**LEGAL ADVERTISEMENT  
HISTORIC PRESERVATION BOARD  
CITY OF PORTLAND**

**PUBLIC HEARING  
562 CONGRESS STREET**

**TO:** Chair Sheridan and Members of the Historic Preservation Board  
**FROM:** Rob Wiener, Preservation Compliance Coordinator  
**DATE:** September 28, 2018  
**RE:** October 3, 2018 **PUBLIC HEARING** – Certificate of Appropriateness for façade replacement

PUBLIC HEARING  
84 COMMERCIAL STREET

1 Proposed Congress Street Elevation

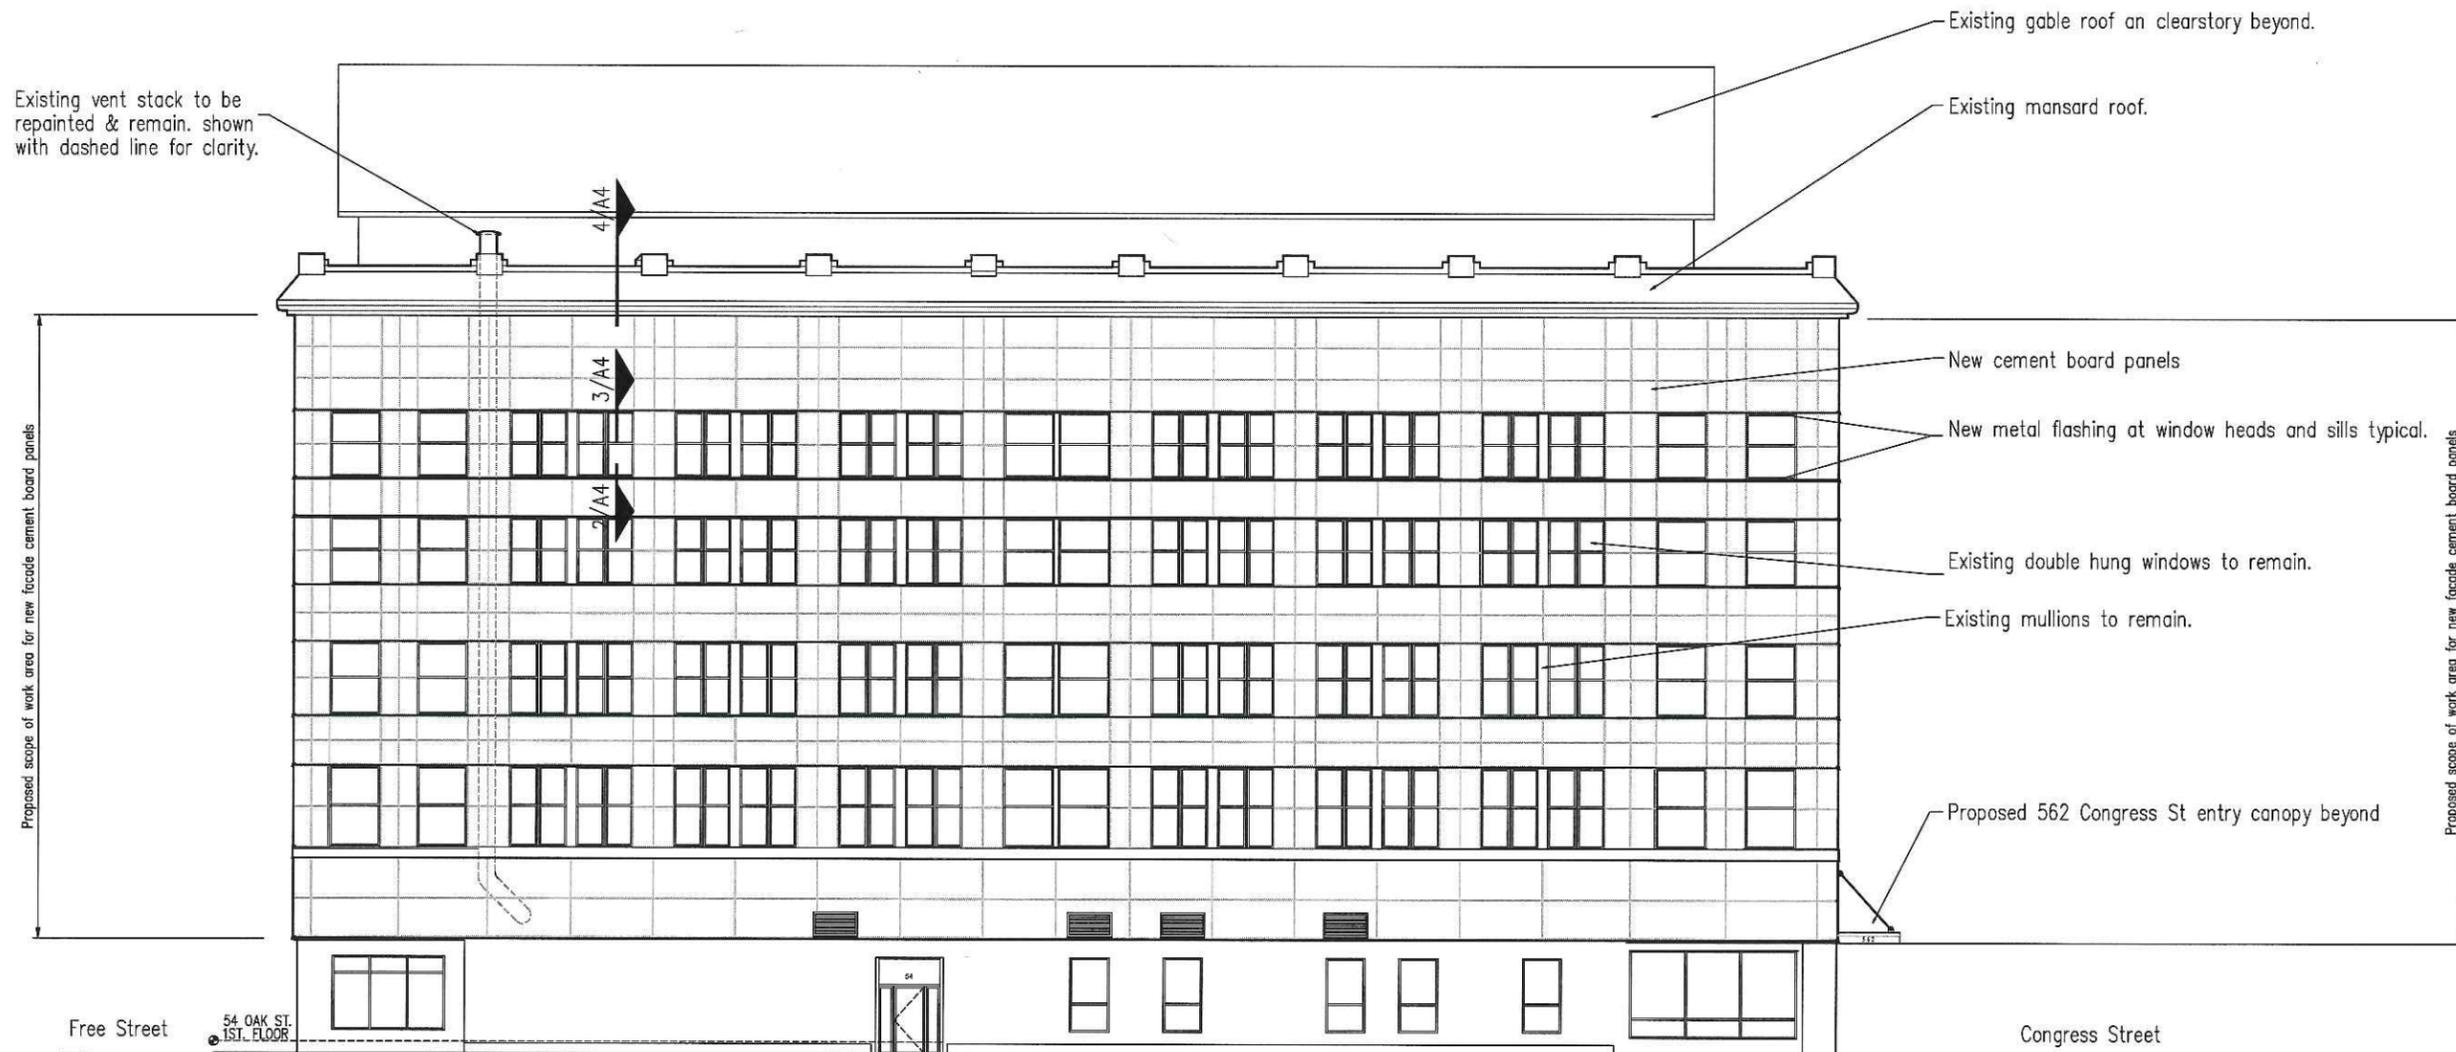
\* The pattern of exposed fasteners is not illustrated in the drawings. This should be illustrated. Are there other ways to attach the panels besides exposed screw heads?

- *The Congress Street elevation has been revised to show fasteners to manufacturer's recommended spacing.*

2 5th floor Window Sill Detail (other floors similar)

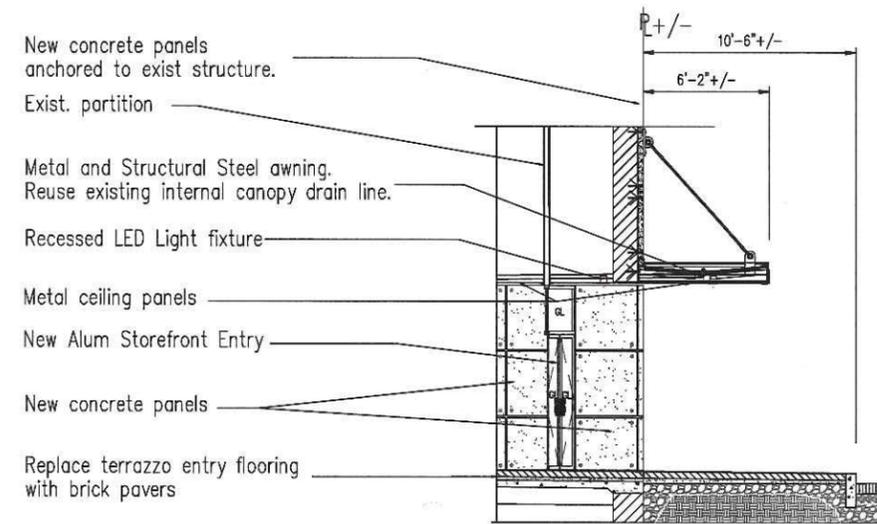
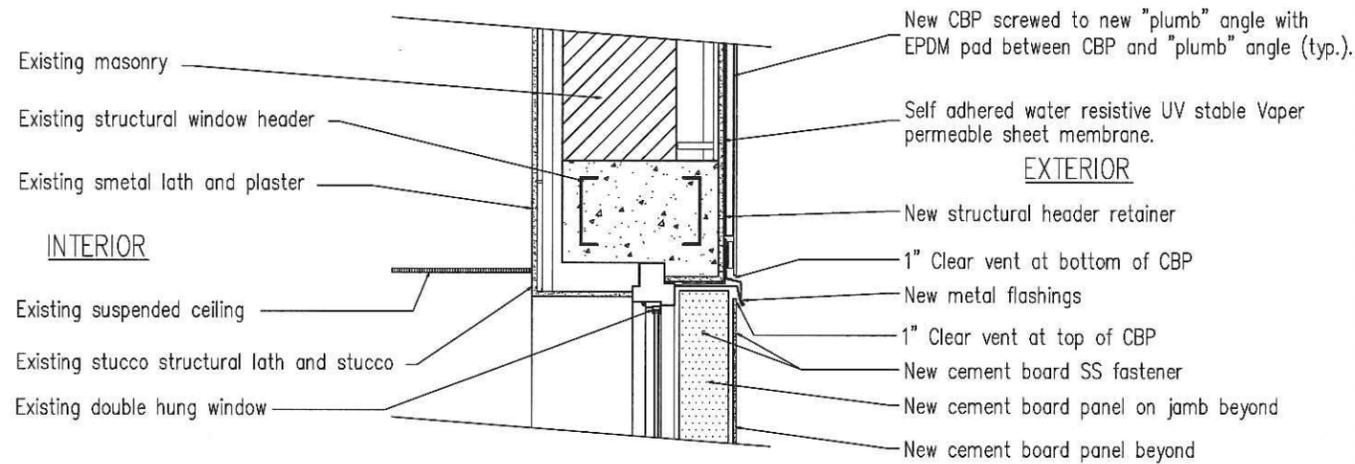
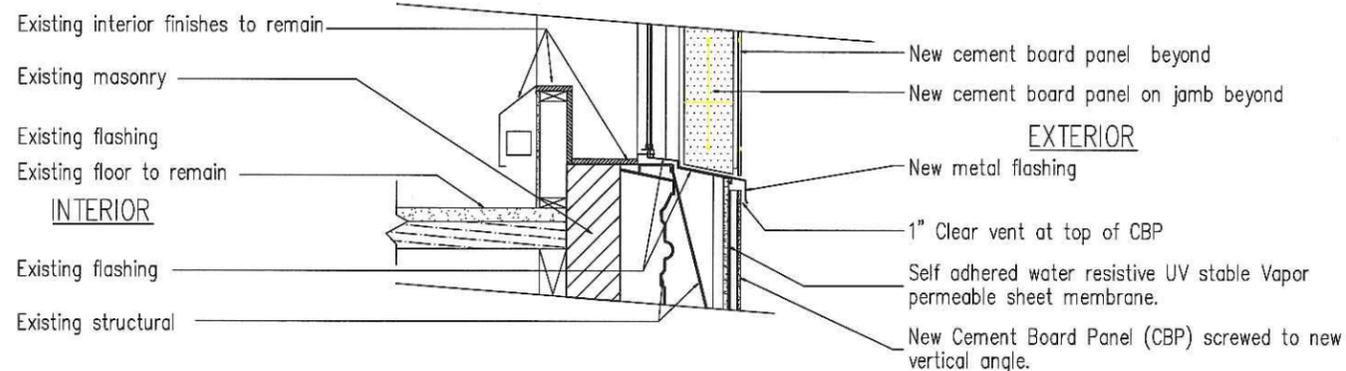
\* How will you finish the bottom edges of the panels above the windows? How are the returns handled?

- *There will be exposed flashing at the head and sills and cement board panels at the jambs. See drawing details.*

1 Proposed 562 Congress St Entry Elevation

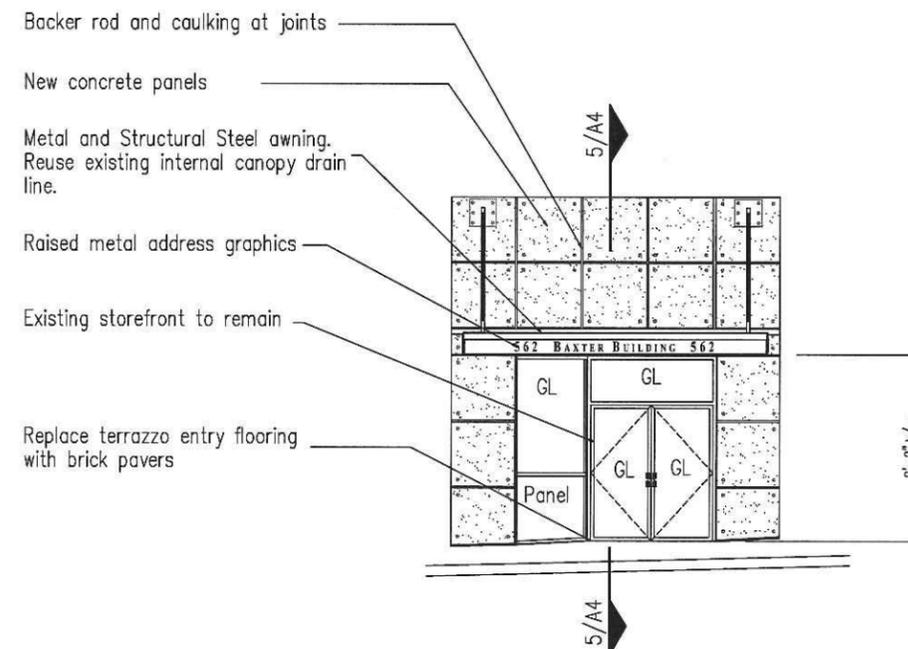
\* Peter stated that a number of design details had not yet been given a lot of consideration (e.g. the main entrance treatment), as the owners had been focusing primarily on the cladding itself. From comments and questions of the Board, it was clear they wanted to see how all the elements of the renovation would relate to one another.

- *Concrete panels are also proposed for the new entry. Because material weight is not as significant at this location and durability/resistance to vandalism is a greater concern precast concrete panels are being proposed. See revised drawings.*

5 | EAST ELEVATION  
1/8" = 1'-0"

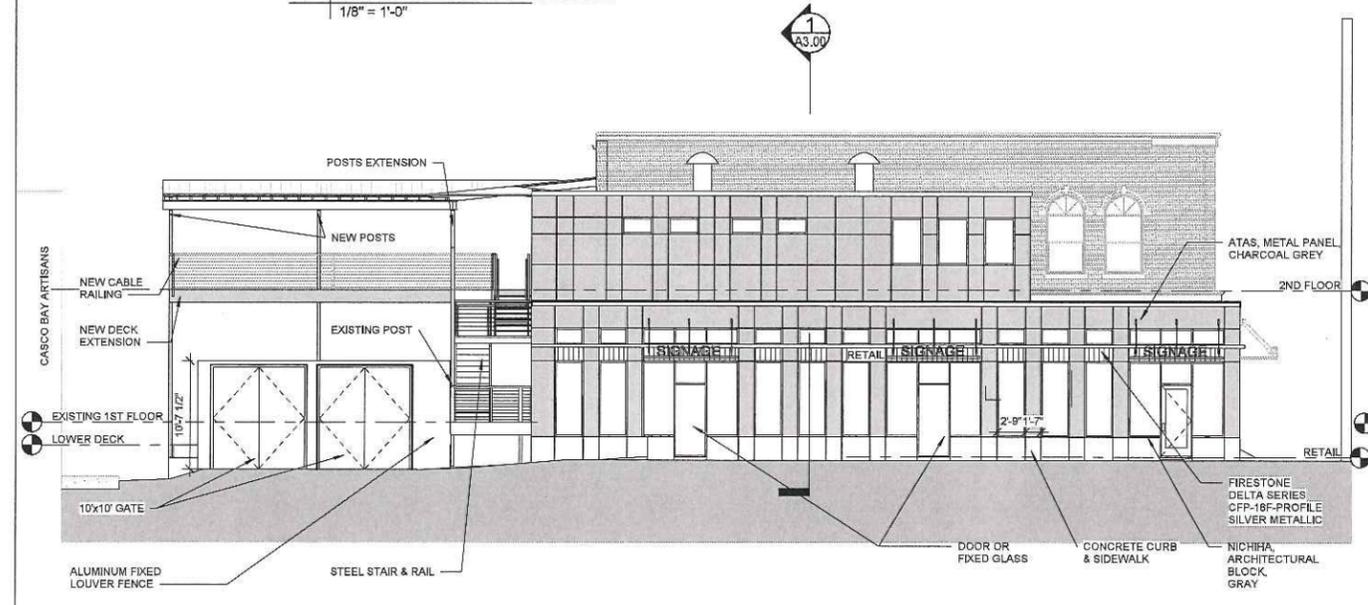
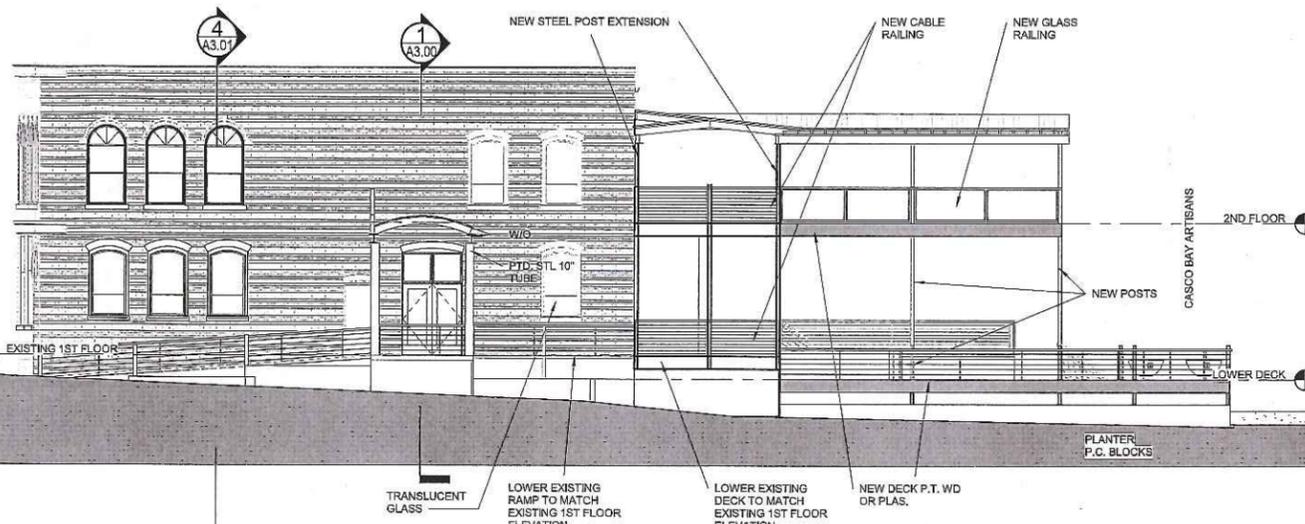
- Position of Elevator Enclosure on East Side: Board members requested that the elevator enclosure be pulled back from the southeast corner of the building to simplify the massing of the addition.

Staff notes one additional design change not included on Mr. Hopkins' list. A number of the large storefront windows on the east elevation of the retail addition have been replaced with narrower windows.

6 | WEST ELEVATION  
1/8" = 1'-0"

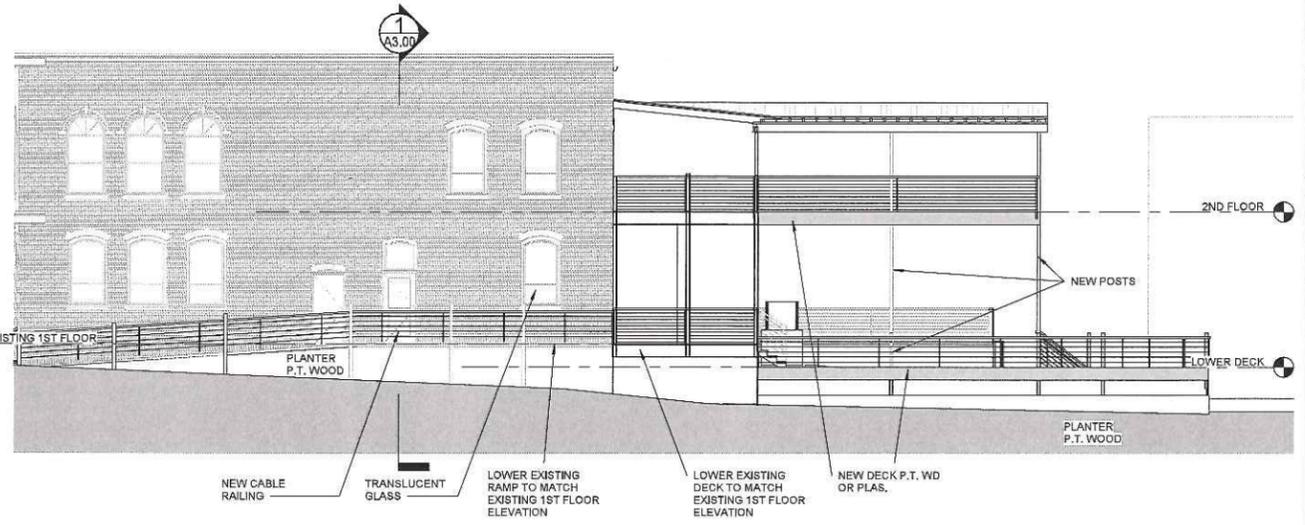
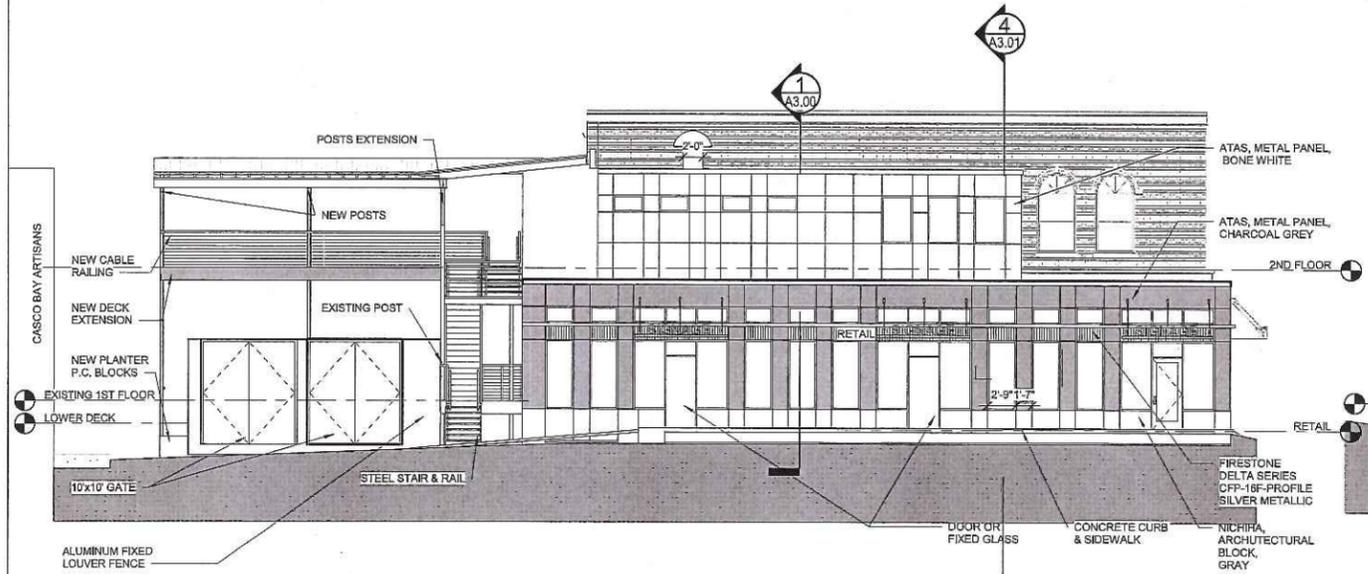
- Proposed Entrance Treatment, West Elevation: Board members expressed concern about the pergola-like structure proposed to highlight the entrance on the west elevation. Board members found the proposed treatment architecturally heavy and exaggerated. They also noted that it diminishes the prominence of the historic main entrance and shifts the directional expression of the existing building. They suggested that lighter support posts be used and the overall treatment toned down. Members also suggested that the same architectural vocabulary be used for the entrance surround as is used for the deck railings.

1. Front door is shown as is
2. Gate removed on commercial street
3. Exit door at ATM location shown at grade
4. Kitchen door noted as hollow metal
5. Kitchen and retail additions shown with same color
6. Mullions eliminated on retail windows
7. Bump out at southeast corner of kitchen addition removed. East wall shown as flush.
8. Roof at southwest corner of exterior roof removed
9. Roof modified for items 6 and 7' Cable rail noted on all guard and hand rails
10. West elevation shown as is
